UNITED STATES PATENT AND TRADEMARK OFFICE

Office Action Summary	Application No.	Applicant(s)	
	10/501,099	WARNER, DONALD H.	
	Examiner	Art Unit	
	JESSIE FONSECA	3633

DETAILED ACTION

Fig. 4: Gill (US 5,896,717)

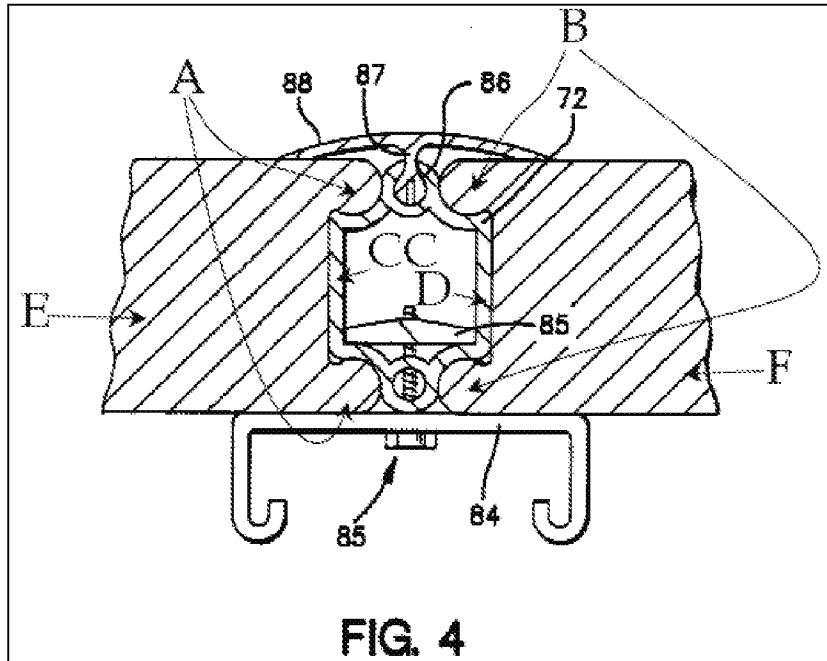
With regards to claim 1: Gill discloses a joint (fig. 4) capable of use with a trim panel comprising:

a first outer cover (E) having an inner surface, an outer surface and a connector portion (A) formed therein (fig. 4);

a second outer cover (F) having an inner surface, an outer surface and a connector portion (B) formed therein (fig. 4);

a connector platform having a first connector portion (CC) and a second connector portion (D), the first connector portion (CC) connected to the first outer cover connector portion (A) and the second connector portion (D) connected to the second outer cover connector portion (F) (fig. 4).

With regards to claim 2: Gill further discloses a joint cover (88) overlying the connector platform, the joint cover (88) covering the connection between the connector platform first connector portion (CC) and the first outer cover connector portion (A) and the joint cover (88) covering the connection between the connector platform second connector portion (D) and the second outer cover connector portion (B) (fig. 4).

With regards to claim 13: Gill discloses a method of forming joint (fig. 4) for a panel comprising:

providing a first outer cover (E) having an inner surface, an outer surface and a connector portion (A) formed therein (fig. 4);

providing a second outer cover (F) having an inner surface, an outer surface and a connector portion (B) formed therein (fig. 4);

connecting the first connector portion (CC) to the first outer cover connector portion (A) and connecting the second connector portion (D) to the second outer cover connector portion (F) (fig. 4)

With regards to claim 14: Gill further discloses providing a joint cover (88) overlying the connector platform, the joint cover (88) covers the connection between the connector platform first connector portion (CC) and the first outer cover connector portion (A) and the joint cover (88) covers the connection between the connector platform second connector portion (D) and the second outer cover connector portion (B) (fig. 4).
